SERVICE INFORMATION NO. SI-D4-130

GARMIN Service Bulletin No. 0823 Revision C
ATA-Code: 34-00

**** MANDATORY ****
SERVICE BULLETIN
NO.: 0823 Rev C

SUBJECT: GDU 104X CRS/BARO Knob Interference

Figure 1

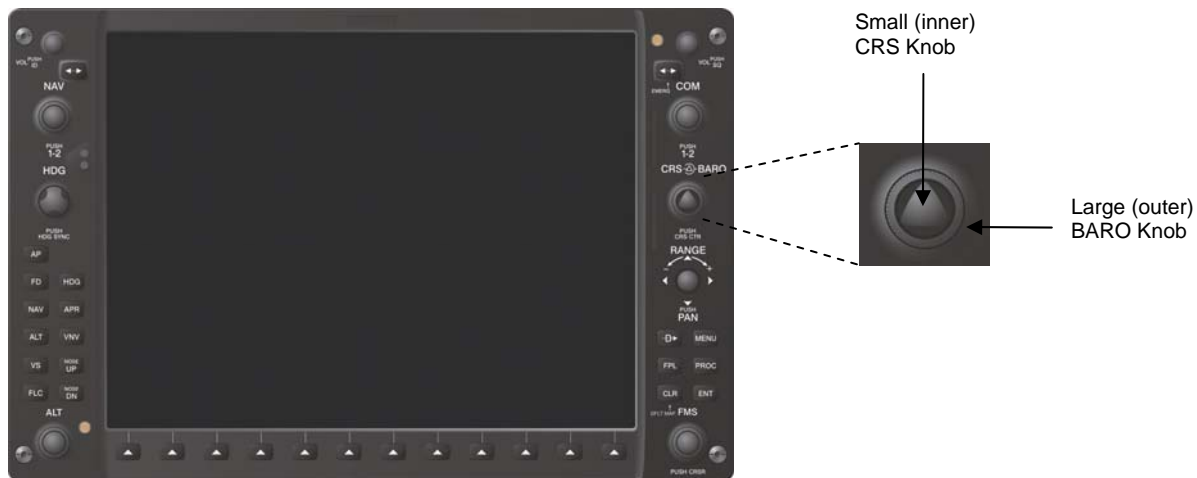
Garmin has identified an issue, whereby the large (outer) BARO knob and the small (inner) CRS knob may interfere with each other.

1. Apply power to the G1000/G900X/G950.
2. Press the CDI softkey on the Primary Flight Display(s) (PFD) to enter VOR mode on the HSI.
3. Rotate the large (outer) BARO knob (refer to Figure 1) a minimum of three complete revolutions in each direction while monitoring the Horizontal Situation Indicator/Digital Course Indicator (refer to Figure 3) on the PFD. If a change in the Horizontal Situation Indicator/Digital Course Indicator is produced while turning the BARO knob proceed to the Modification Instructions.

4. Rotate the small (inner) CRS knob (refer to Figure 1) a minimum of three complete revolutions in each direction while monitoring the Barometric Altimeter Setting (refer to Figure 3) on the PFD. If a change in the Barometric Altimeter Setting is produced while turning the CRS knob proceed to the Modification Instructions.
5. Repeat Steps 3 and 4 for each affected GDU.

This service bulletin contains instructions on how to test for knob interference and remove/replace the CRS/BARO knobs, as required.

1. Grasp the small (inner) CRS knob and firmly pull the knob off the shaft.
2. Discard knob.
3. Grasp the large (outer) BARO knob and firmly pull the knob off the shaft.
4. Discard knob.

Figure 4

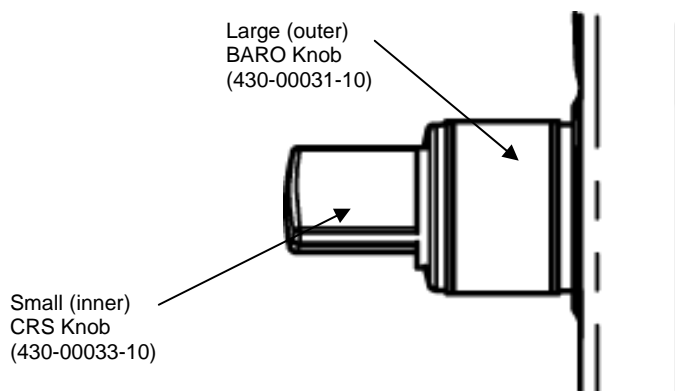
If CRS/BARO Knob interference is confirmed, perform the steps below to replace the CRS/BARO Knob. New knobs can be obtained through a Garmin Service Center or Aircraft OEM under Garmin part number K00-00446-00.

5. Grasp the large (outer) BARO knob (insuring proper orientation) and place it over the shaft.
6. Align the flat side of the knob insert with the flat side of the shaft.
7. Press down firmly to ensure knob is completely seated, refer to Figure 4.
8. Grasp the small (inner) CRS knob (insuring proper orientation) and place it over the shaft.
9. Align the flat side of the knob insert with the flat side of the shaft.
10. Press down firmly to ensure knob is completely seated, refer to Figure 4.
11. Perform the CRS/BARO Knob Interference Test (contained in the TESTING PROCEDURE section) again to confirm there is no interference.
12. Accomplish aircraft logbook entry to return aircraft to service in compliance with this service bulletin.
